AGENDA • PLANNING COMMISSION
Council Chamber, 1033 Fifth Street, Clovis, CA 93612 (559) 324-2340
www.cityofclovis.com

July 23, 2020

REPORT TO THE PLANNING COMMISSION

SUBJECT: Consider Approval - Res. 20-xx, SPR2020-002, A request to consider an appeal of the Site Plan Review (SPR) approval for an industrial development located at 561 N. DeWitt within the Dry Creek business Park (Project). Palm Bluffs Real Estate Inc., property owner; Partners 425 LLC, Bear Claw Investments LLC, Dan and Joey Properties LLC, appellants; Dowling Aaron Incorporated - Andrew Slater, representative.

NORTH (SPRUCE STREET SIDE) ELEVATION

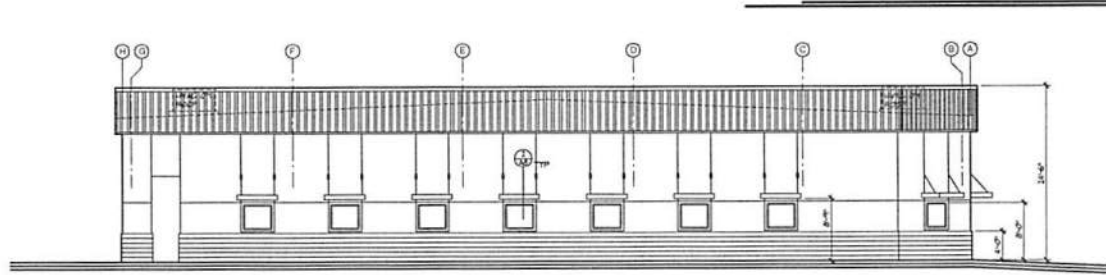
*Provide Planning staff with a color rendering inclusive of a color and material key

5 ISA SYMBOL

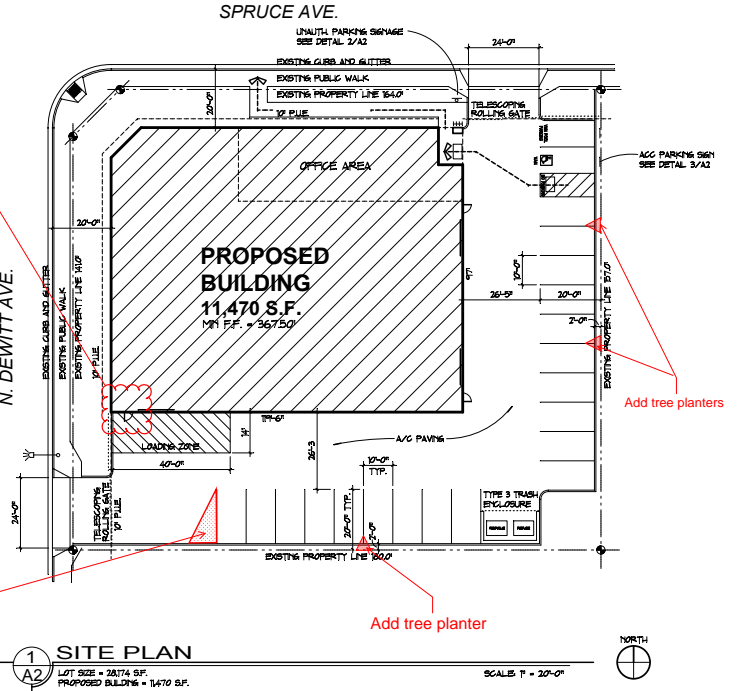
Doorway may not open into the required loading zone. Relocate the designated loading zone

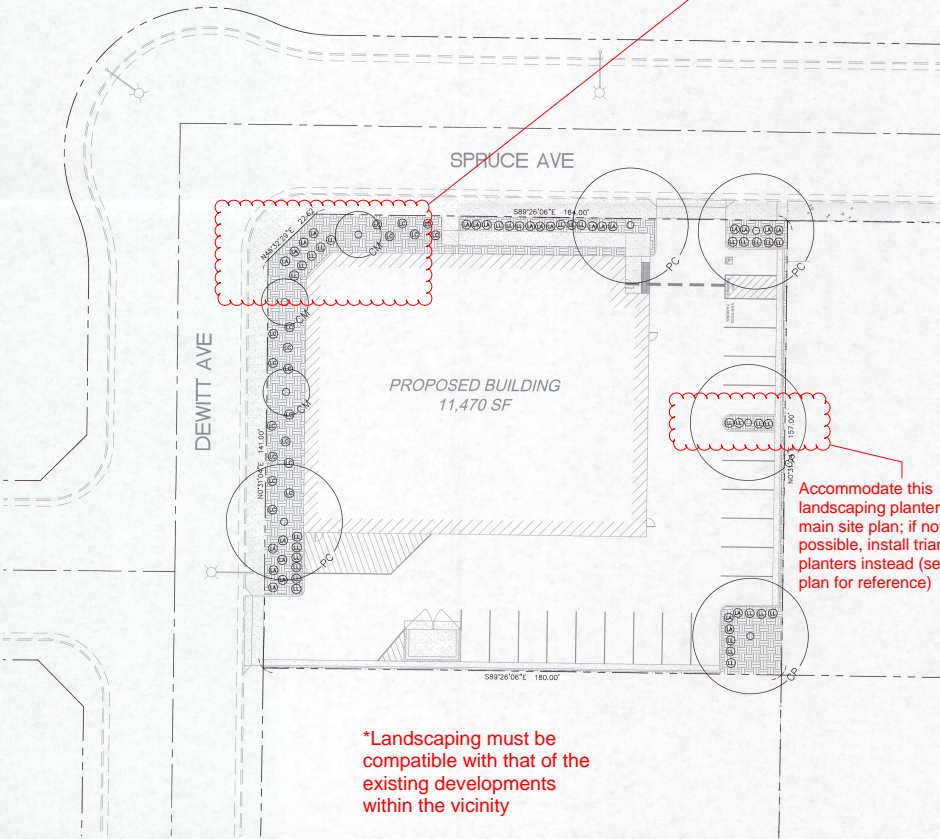
Landscaping in this area should be enhanced to provide visual appeal

*Landscaping must be compatible with that of the existing developments within the vicinity

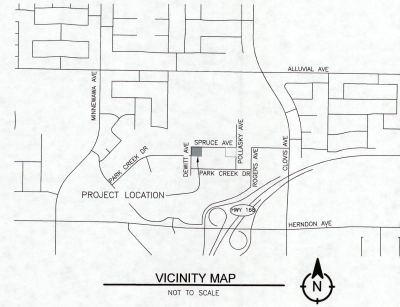
Accommodate this landscaping planter into the main site plan; if not possible, install triangular planters instead (see site plan for reference)

Proposed Shopping Center
 NEC of North Willow Ave & West Alluvial
 Clovis, CA 93611

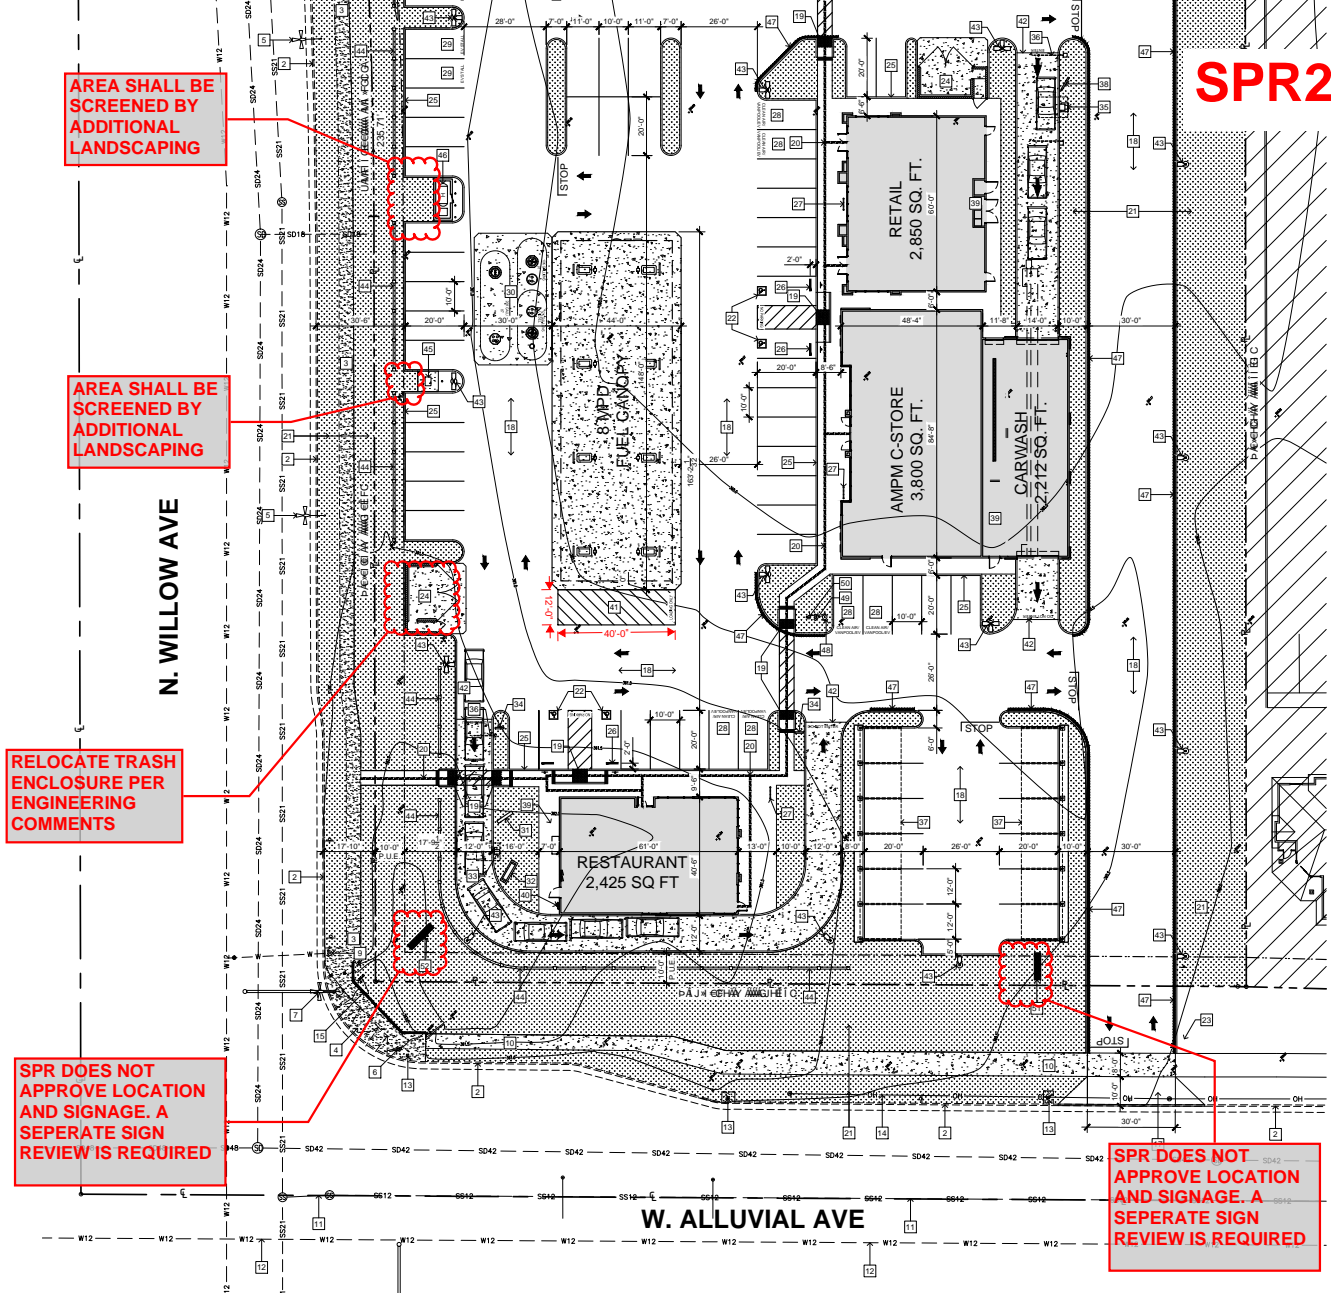
AREA SHALL BE SCREENED BY ADDITIONAL LANDSCAPING
